ATTACHMENT 2

TO P-93045

PROPOSED CHANGE

DECOMMISSIONING OF THE FORT ST. VRAIN NUCLEAR GENERATING STATION

Figure 1

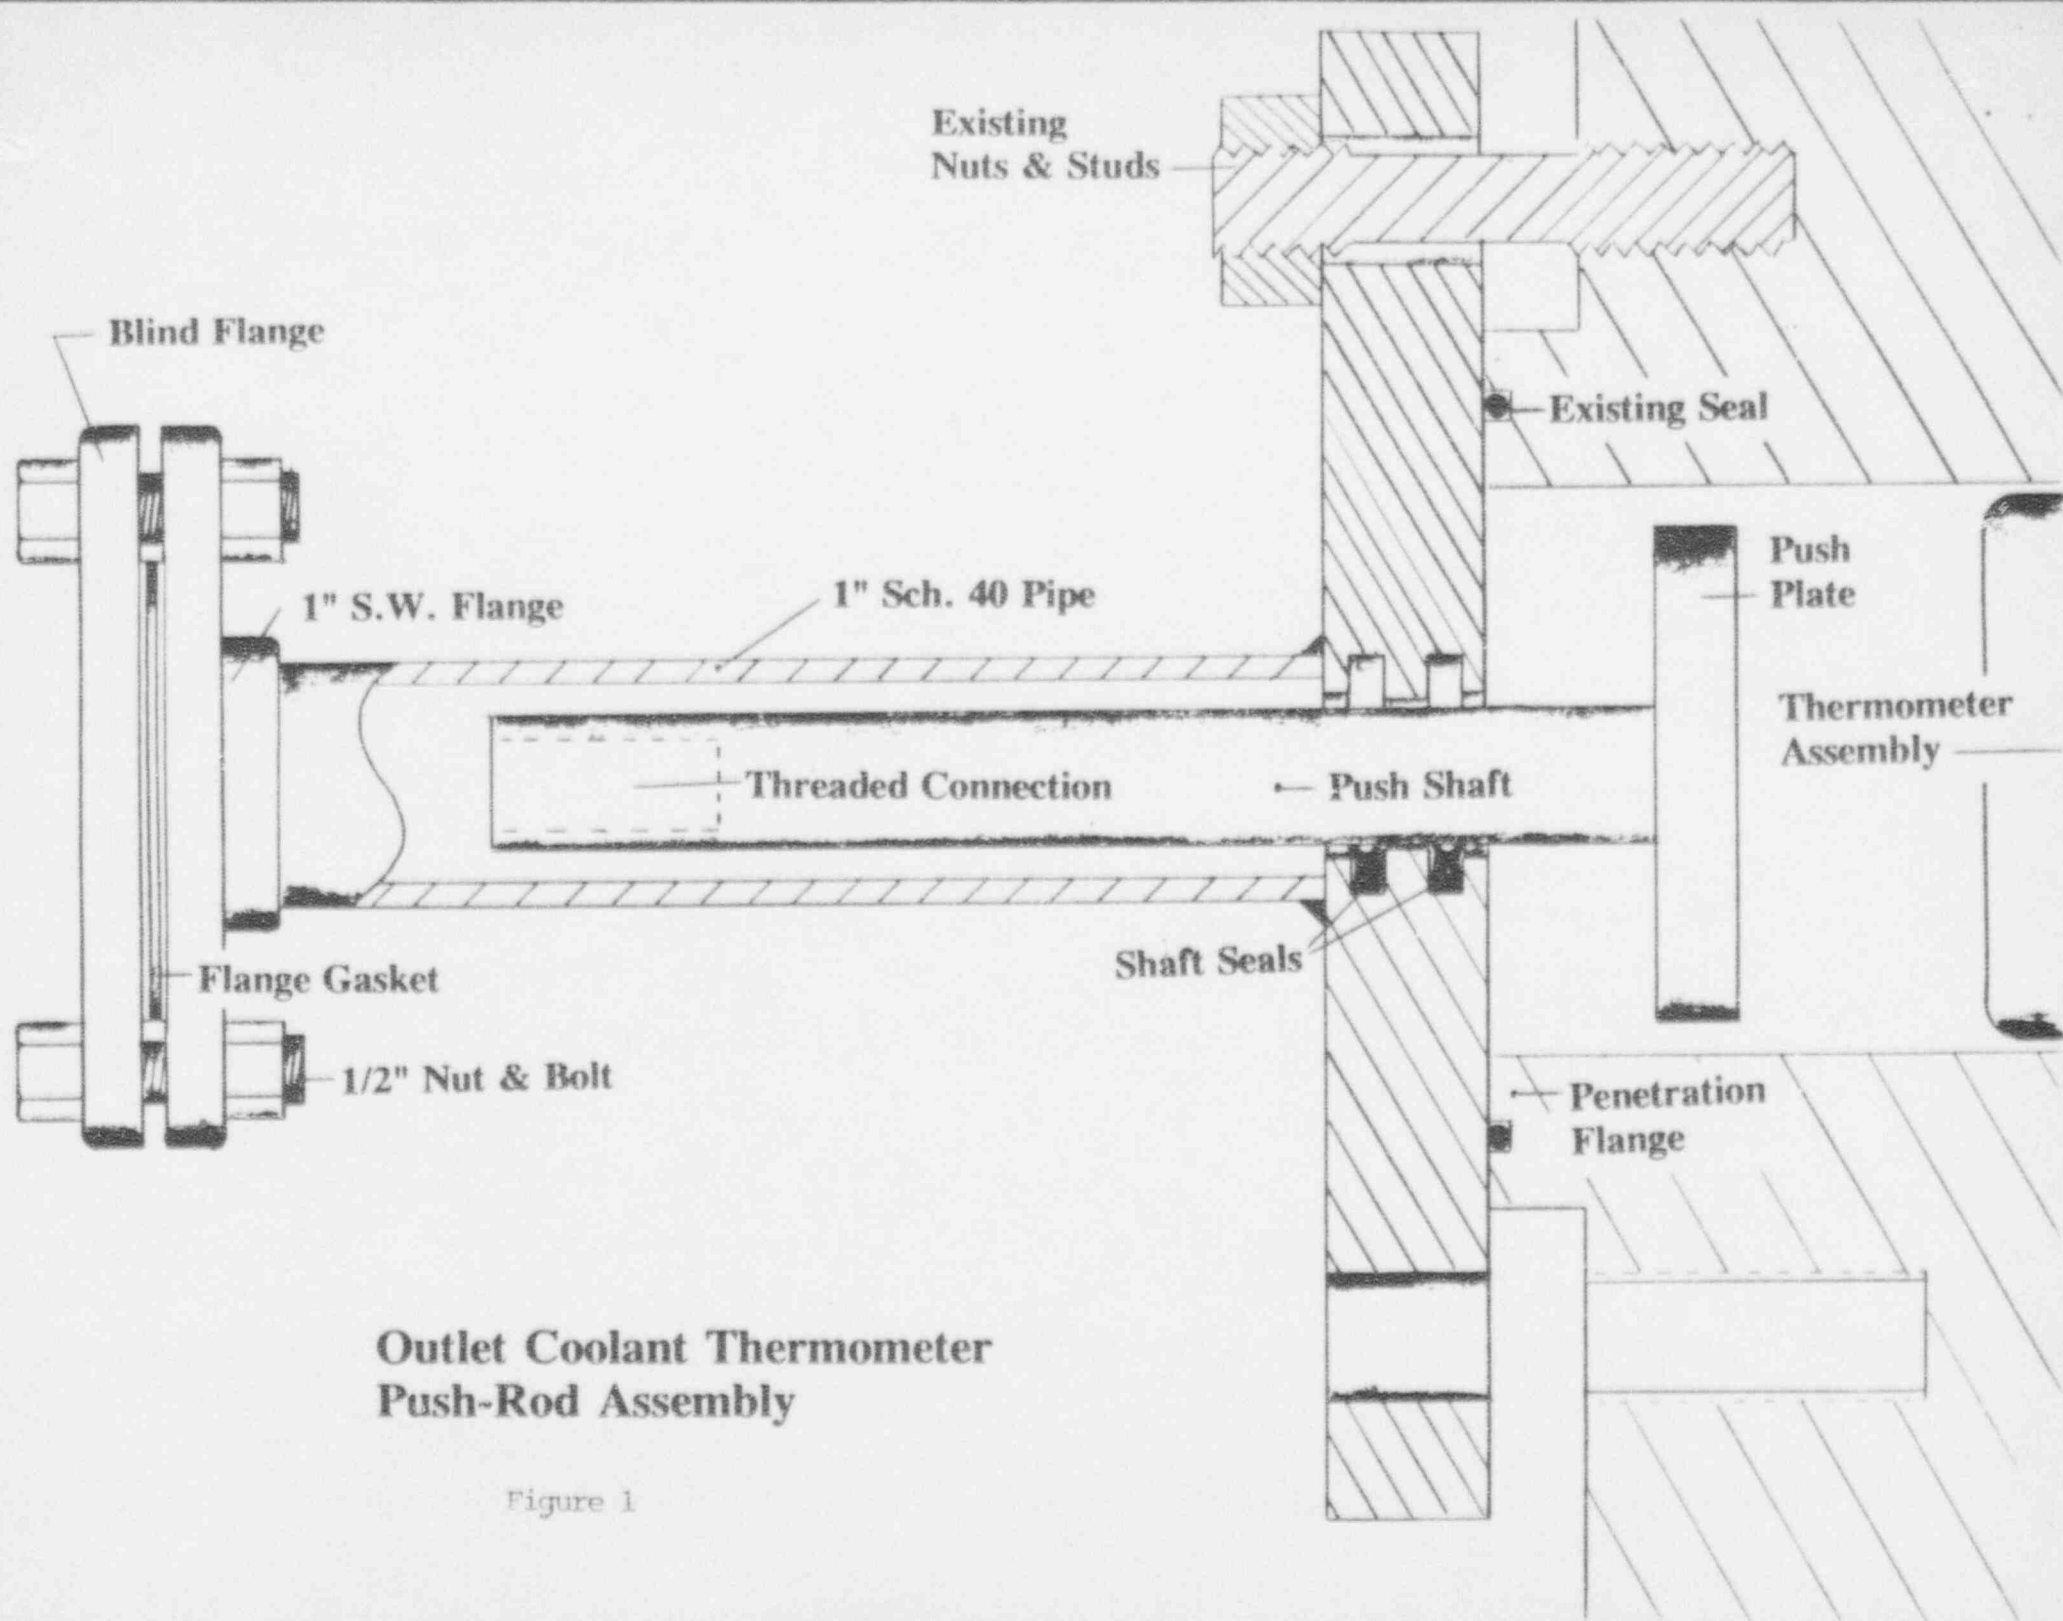
PSC has already installed an outlet coolant thermocouple push rod assembly, including a blind flange as shown on Figure 1, on each of the seven thermocouple penetrations. Initially, the core support blocks that do not have thermocouples located inside them will be removed. Then, the thermocouple penetration covers (blind flanges) are removed, one at a time. A smooth threaded rod is attached to the push rod assembly and the thermocouples are pushed in the inward direction (inward relative to the PCRV exterior) until the thermocouples are exposed in the cavity created by the removed core support floor blocks. The push rod is then withdrawn, unthreaded, removed, and the blind flange is re-installed. The thermocouples may then be grappled and pulled further into the underwater cavity, where they can be cut as necessary and removed for disposal.

The penetration blind flange and redundant shaft seals are designed to withstand the static load generated by the head of water pressure acting on them. During use of the push rod assemblies, the wiper-type shaft seals are expected to prevent shield water leakage out of the penetrations.

Any minor leakage past the shaft seals could be readily contained and collected. In the unlikely event that the redundant shaft seals would completely fail, the resultant leak rate would be less than two gallons/minute. In this event, workers operating the push rod assembly could re-install the blind flange to isolate leakage past the failed seals, since the total force on the flange would be approximately 16 pounds-force. All radiological provisions will be in place prior to performance of these evolutions (i.e., water leakage collection, spray shields, water proof protective clothing). Worker doses from this leakage would still be much less than the doses that would be received from removing the 200 R/hr thermocouples through the penetrations. This small amount of leakage due to failure of the redundant shaft seals is well within the make-up capability of the shield water system.

Blind flanges for the seven outlet coolant thermocouple penetrations may be removed, one at a time, during underwater removal of the thermocouple assemblies. During this time, PCRV shield water leakage will be prevented by redundant seals on the thermocouple removal tools.
